Product / Process Change Notification

N° 2021-001-A

Capacity extension with the introduction of an additional assembly and final test location at Great Team Backend Foundry, Inc., China for dedicated DirectFET products in WDSO package

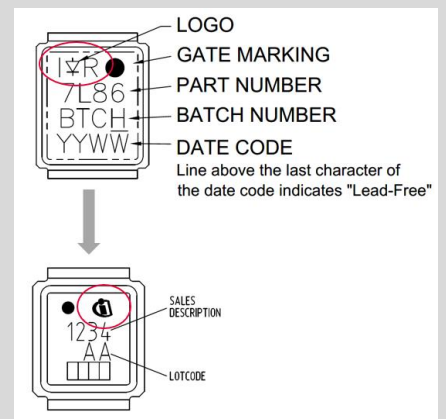
Marking

■ International Rectifier (IR) Logo

■ International Rectifier (IR) Logo

And

■ Infineon Logo (for production from GTBF)

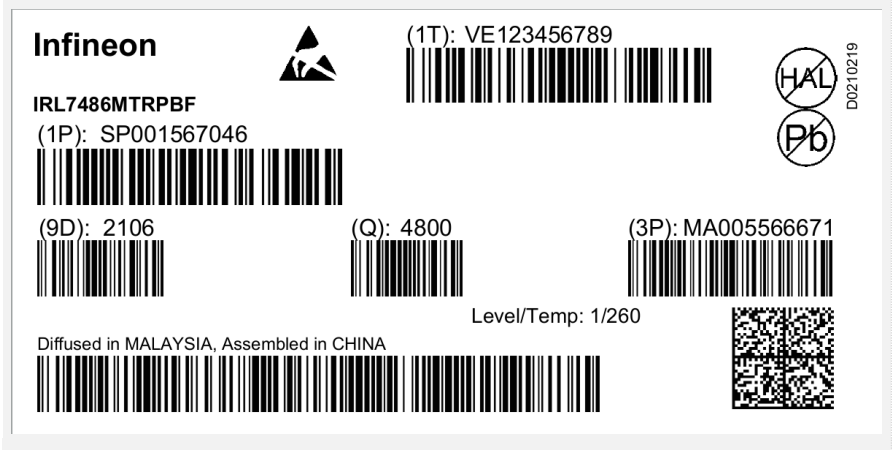
Package nomenclature

■ M-WDSO-5

■ MG-WDSO-8 (only for IRF60DM206 for harmonization purpose)
